INITIAL RECOMMENDATION MEETING

1414 10th Ave
Seattle, Washington

DPD Project No.: 3013040
August 01, 2012

INITIAL RECOMMENDATION - CONTENTS

EAST ELEVATION @ 11TH AVE

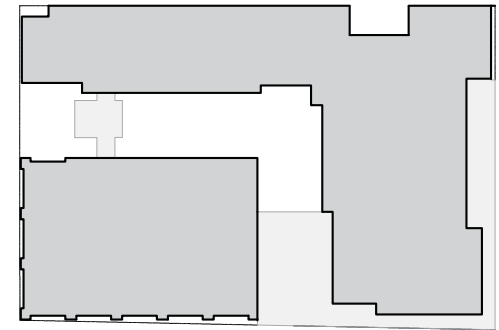
The setback departure at SE corner may be positively considered if the design is highly glassy and transparent.

The design should meet the scale goals of the overlay district.

The board supports the design which floats over the older edifice.

The center portion of the elevation should enjoy a larger setback and be more aligned with code standards.

- Full setback of 15' at mid-lot over Madison Park 2
- Three distinct volumes with three distinct expressions across the facade
- There is a 7' setback at corner glass element.

WEST ELEVATION @ 10TH AVE

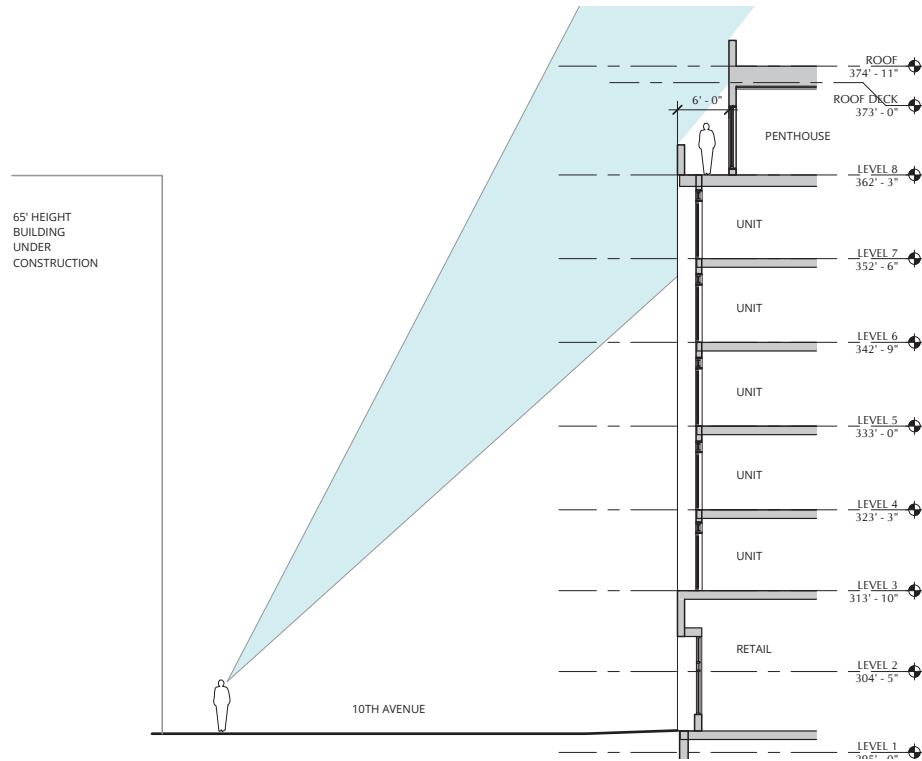
The corner should strive to create a sense of scale familiar to the neighborhood context.

The building should have a tall ground floor height with large glazing.

The building should contrast the abutting buildings

The brick should fully wrap all sides of the building

The building should set back from the property line to appear more consistent with other buildings.

- The top floor set back 6'-0" on all sides
- Retail base facade has been raised to the bottom of level 3 to create a taller-feeling retail street character. This composition is now ~20' feet from sidewalk to cornice.
- SW building is still 75'-0" tall

NORTH WALL ELEVATION @ 10TH AVE

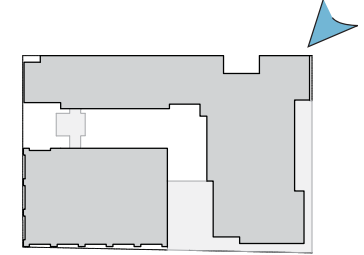
The board was pleased with the direction of the design of the north elevation, including the step back and the inclusion of windows.

Vertical and horizontal windows should be authentic and use restraint in the composition

Changes in material should occur with shifts in plane

- Two units on each level now face north on the west side of the building, increasing the interest of the north facade

ENTRY PLAZA @ 10TH AVE

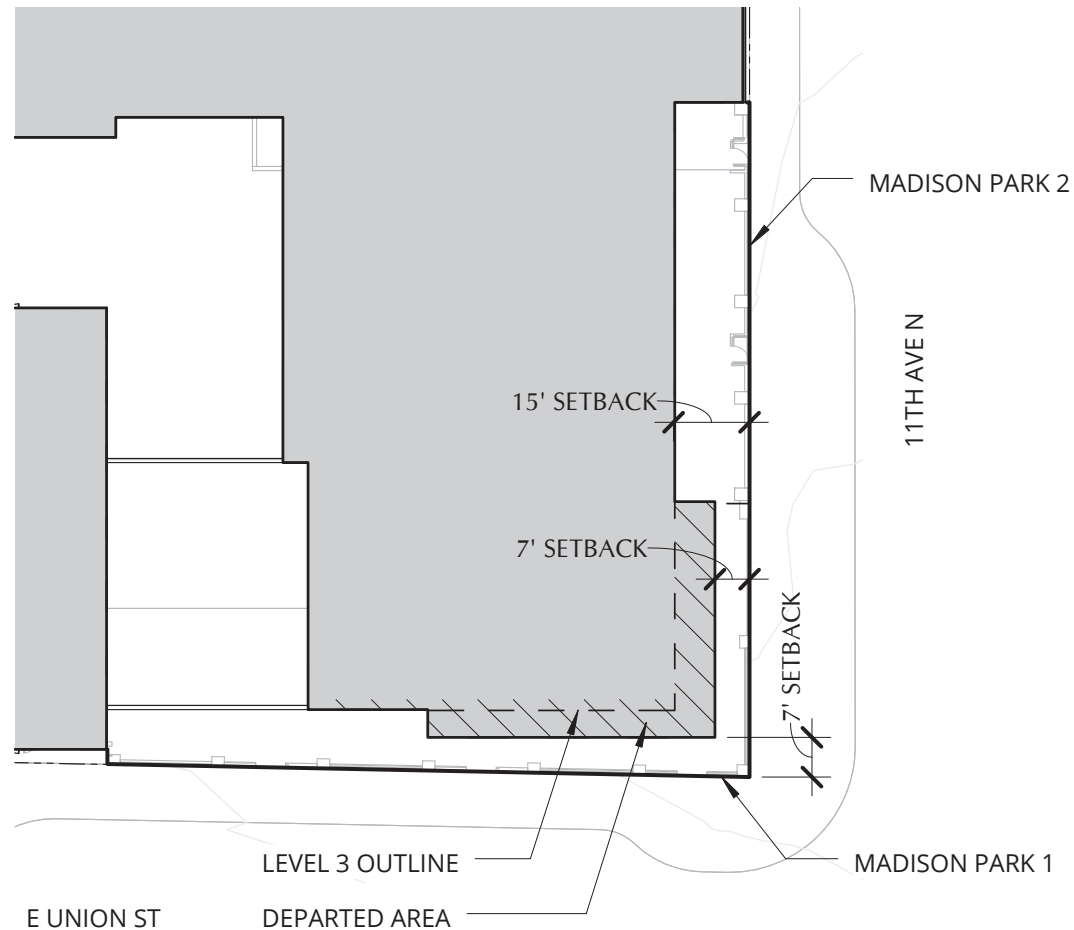
The presence of driveways and service areas should be minimized to the greatest extent possible.

The potential for public or semi-public ground level open spaces should be considered.

The board indicated support for the departure request provided that the 11th Ave facade is well scaled and that the mid-block setback departure is eliminated.

- The new design for lobby entrance is light, glassy, and allows the public to see the interior courtyard.
- The public area at the lobby is suitable for sidewalk retail and restaurant uses and is both a private and public amenity.

PLAN: SETBACK DEPARTURES REQUESTED

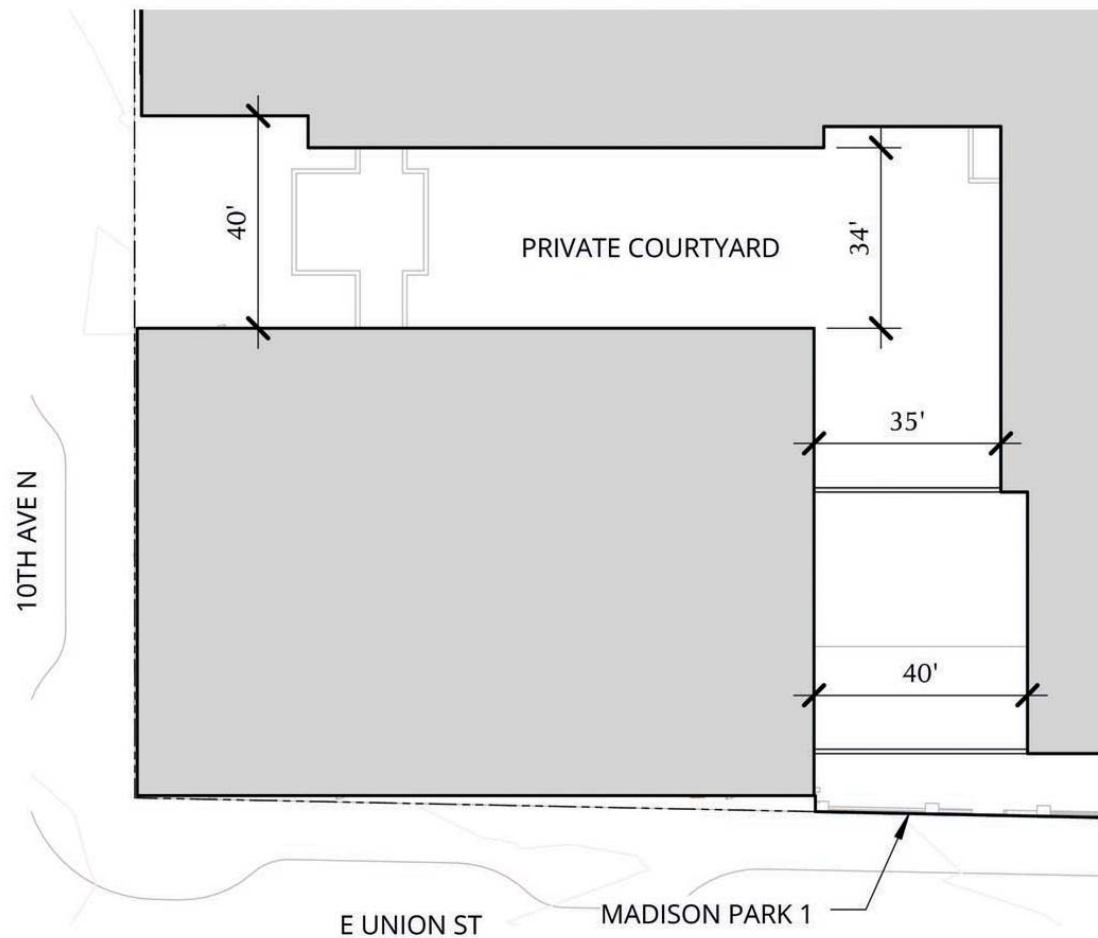
Land use code calls for a 15' setback of new structure from the facade of a character structure being retained. In the case of Madison Park 1, we will be using a contrasting architectural style for the new building above it and believe that the best arrangement is a 7' setback from the facade of the character structure.

This departure would allow us to place a large separation over the remaining portion of the existing character structure, giving further deference to the identity of the building.

The setback at Madison Park 2 is now 15' and requires no departure.

PLAN: SEPARATION DEPARTURES REQUESTED

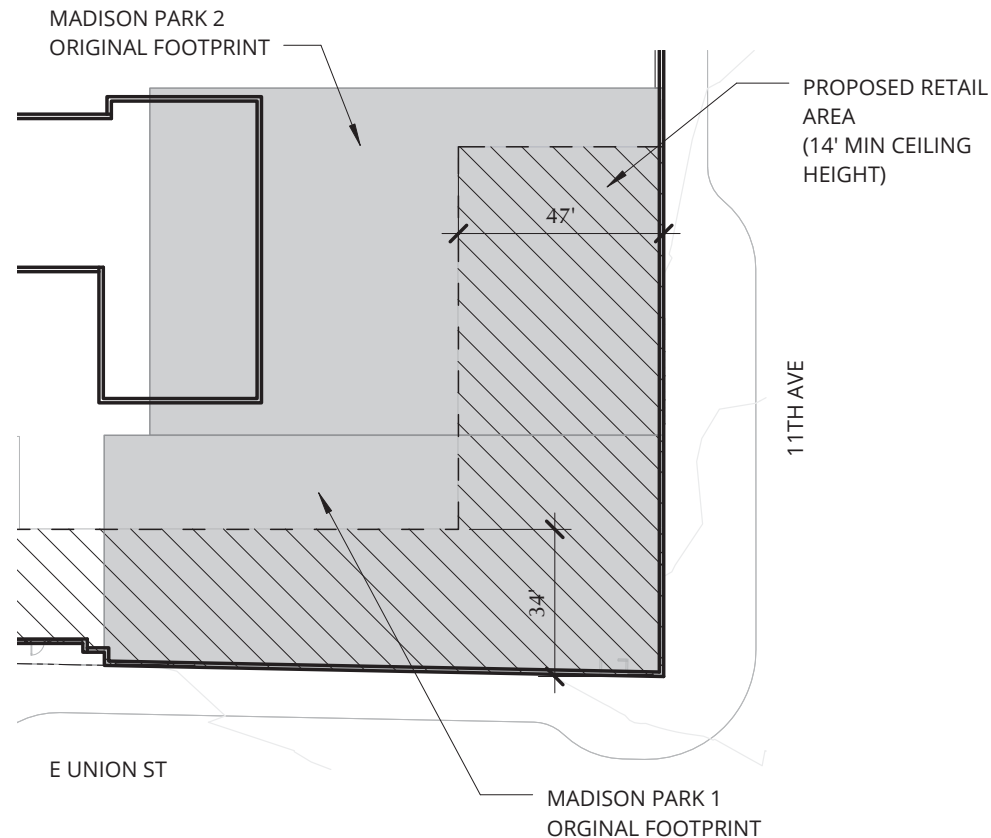
Land use code calls for a 40' separation between two portions of a structure above 35' which are both subject to the floor size limit, and would be measured separately for the purposes of a total floor size limit.

This departure allows interior courtyard facades to be more articulated than they would be otherwise. EDG 01 requested that we find more ways to articulate both the interior courtyard facades and exterior street facades, and this departure allows us the flexibility to achieve that articulation.
